**WORCESTER HOUSING AUTHORITY**  
Worcester Housing Authority (WHA)  
81 Tacoma Street  
Worcester, MA 01605

**ADDENDUM NO. TWO**  
**PLANS AND SPECIFICATIONS FOR:**  
**Backflow Preventer Installation**  
**MA 12-13, Webster Square Towers West and East**

In accordance with documents prepared by: Garofalo Design Associates, Inc. 384 Lowell Street, Unit 105 A&B, Wakefield, MA 01880

SK-2

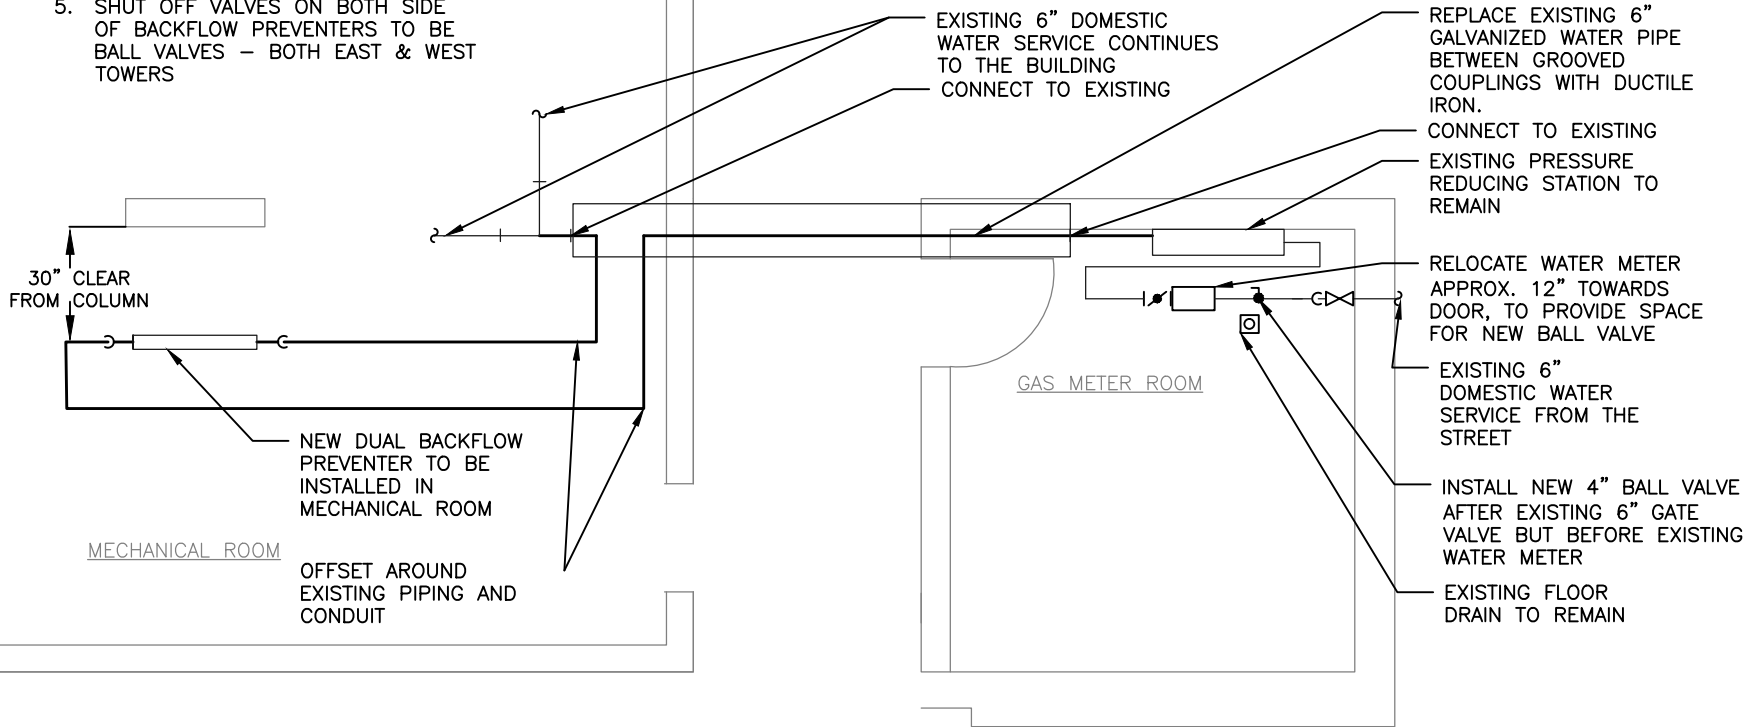
3. **ANSWER:** *See Addendum #2 for relocation of backflow preventers across hall to mechanical room, where more space is available.*
4. **QUESTION:** In the West Tower, there are some electrical lines and boxes on the wall where the new backflow preventers are shown to be anchored. Will these be relocated by others?

**ITEM No. 5: P-1.0 (PLUMBING PLAN)**

**DELETE:**

*Detail: 3 – WEBSTER SQUARE EAST TOWER 1050 MAINT ST. PLUMBING PLAN*

**INSERT:**

*SK-2 "New Backflow Preventer & Valve Replacement" & ALTERNATE NO. 2*

INSTALL DUAL 4" BACKFLOW PREVENTER IN MECHANICAL ROOM AS SHOWN-IN LIEU OF GAS METER ROOM.

SK-2 DESCRIPTION INDICATES WORK TO BE PERFORMED AT 1050 MAIN STREET (EAST TOWER). THAT WORK INCLUDES THE FOLLOWING:

1. RELOCATION OF THE DUAL BACKFLOW PREVENTERS TO THE MECHANICAL ROOM, 9' ACROSS THE CORRIDOR FROM THE "GAS METER ROOM."
2. MOVING THE WATER METER ABOUT A FOOT TOWARDS THE DOOR AND THE INSTALLATION OF A NEW 4 INCH BALL VALVE BETWEEN THE 6 INCH GATE VALVE AT THE WATER ENTRANCE AND THE 4 INCH WATER METER.
3. CLEANING OF STRAINERS, REPLACEMENT OF THE STRAINER BRACKETS, AND INSTALLATION OF BALL VALVE BLOW DOWNS ON THE TWO STRAINERS. THIS WORK IS IDENTIFIED AS "ALTERNATE NO. 2"
4. ALL SHUT-OFF VALVES AT THE PRESSURE REDUCING STATION ARE ALREADY MODERN BALL VALVES WITH STAINLESS STEEL BALL AND TEFLON SEATS.
5. WE ARE NOT REPLACING THE PRESSURE REDUCING VALVES. TYPICALLY THESE VALVES ARE VERY EXPENSIVE THAT LIKELY ONLY REQUIRE CLEANING AND ADJUSTING.
